4. CASE 21.101, 20 ARNOLD STREET, Zachariah Carpenter House, 1795-96 (COLLEGE HILL)  
Federal; 2½ stories; gable roof; clapboard; 4-bay facade with pedimented fanlight doorway flanked by Ionic pilasters.  
CONTRIBUTING

**Proposal:** The scope of work proposed consists of Major Alterations and includes:

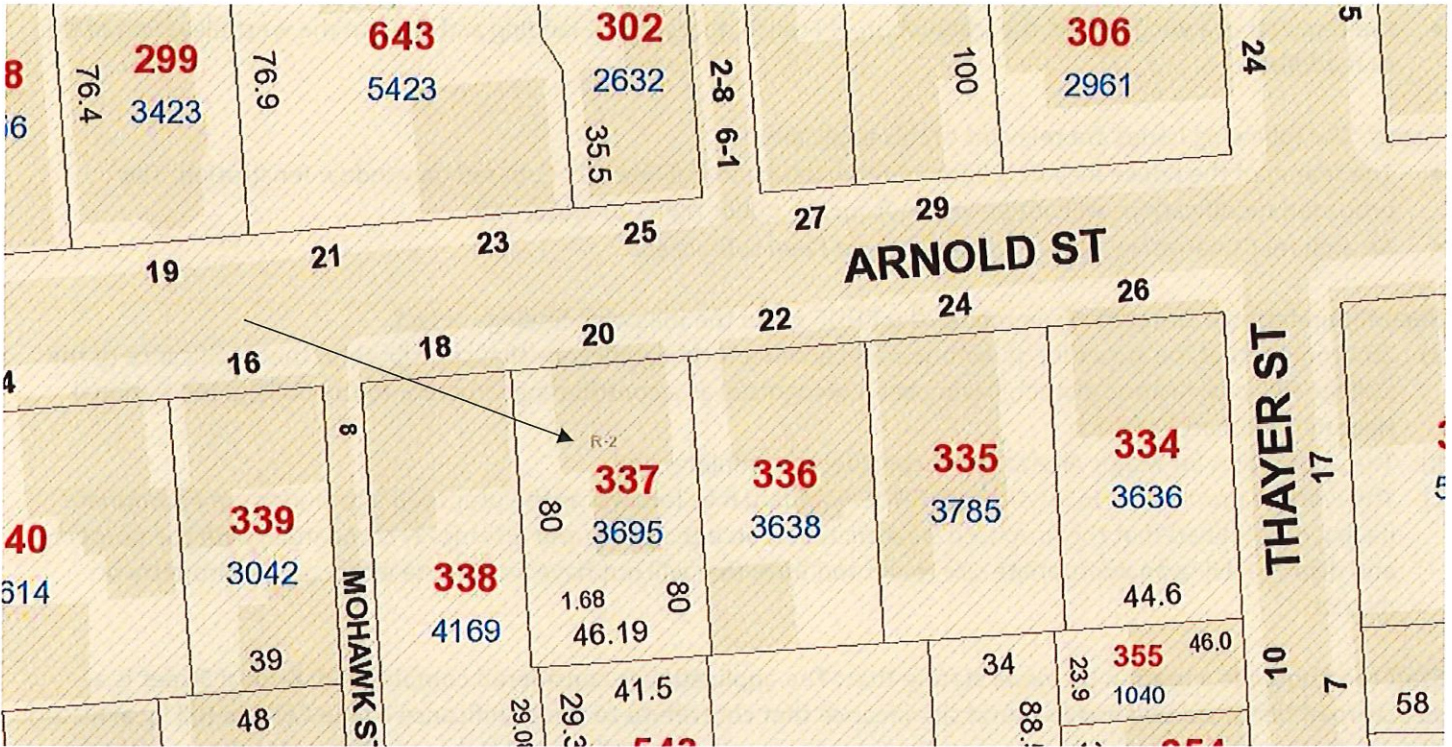
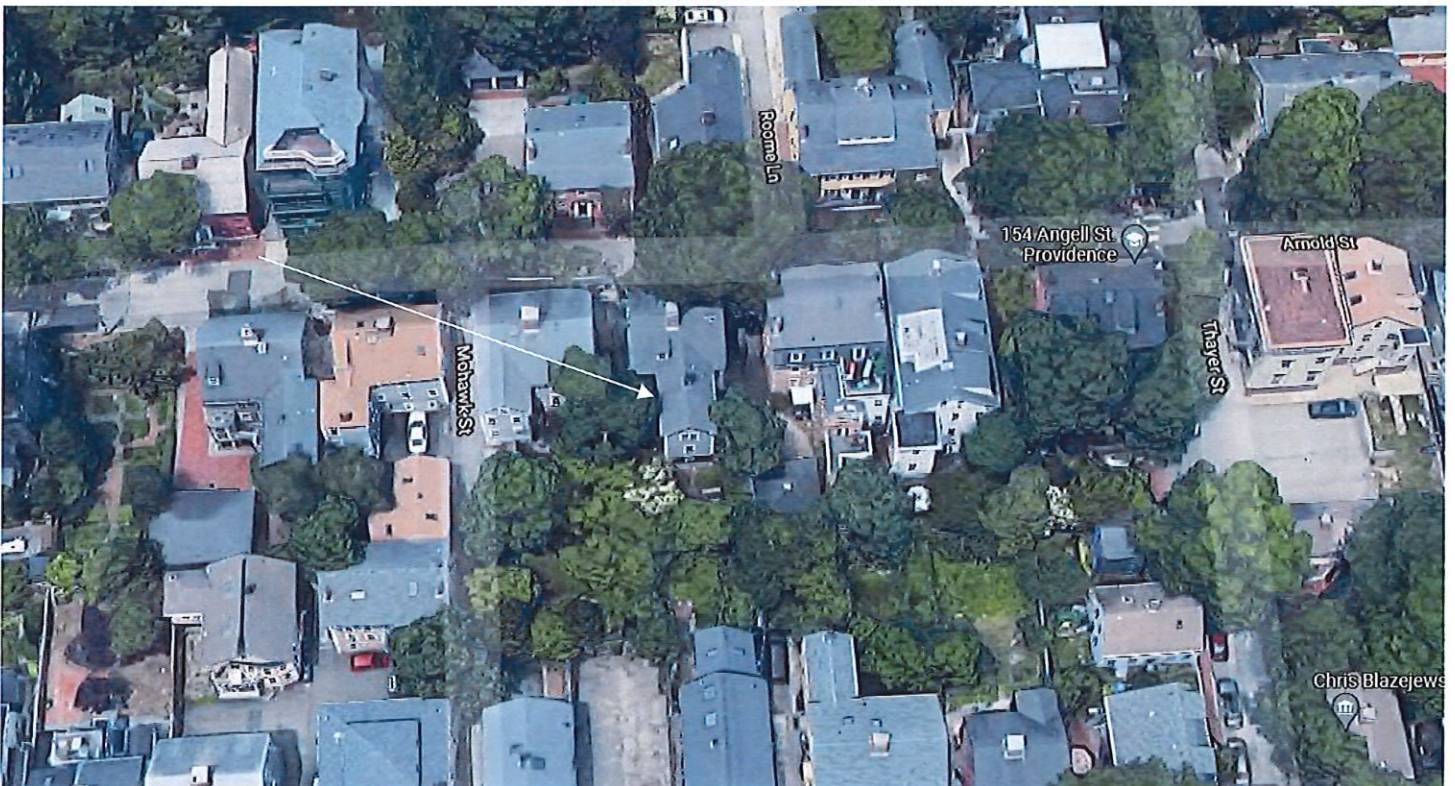
Arrow indicates 20 Arnold Street.

Arrow indicates project location, looking north.
